APPLICATION NO.	FILING DATE	FIRST NAMED INVENTOR	ATTORNEY DOCKET NO.	CONFIRMATION NO.
10/788,771	02/27/2004	Pieter G. Wybro	MOD013/145573	8450

Office Action Summary

DETAILED ACTION

Fig. 10

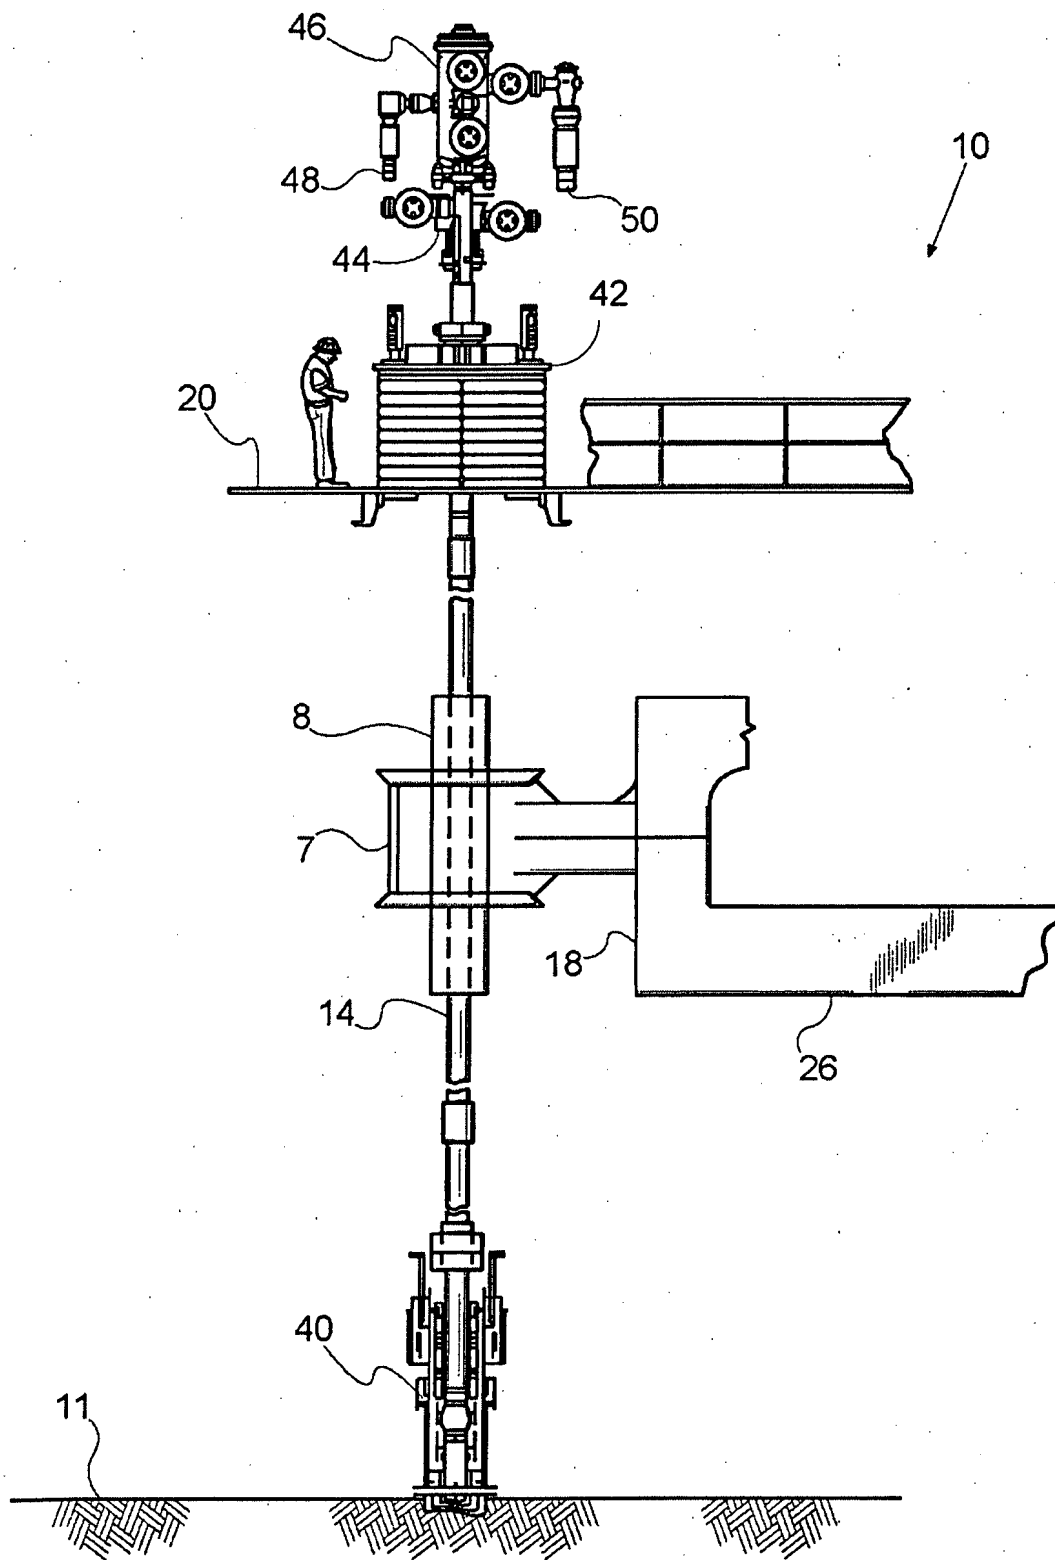
3. The proposed replacement sheet of drawings filed 10/30/2007 has not been approved by the examiner, as such is considered to be New Matter. There is no basis in the disclosure as originally filed for the element in the figure to now be called the passive riser tensioner.

Not Approved See 11/24/07
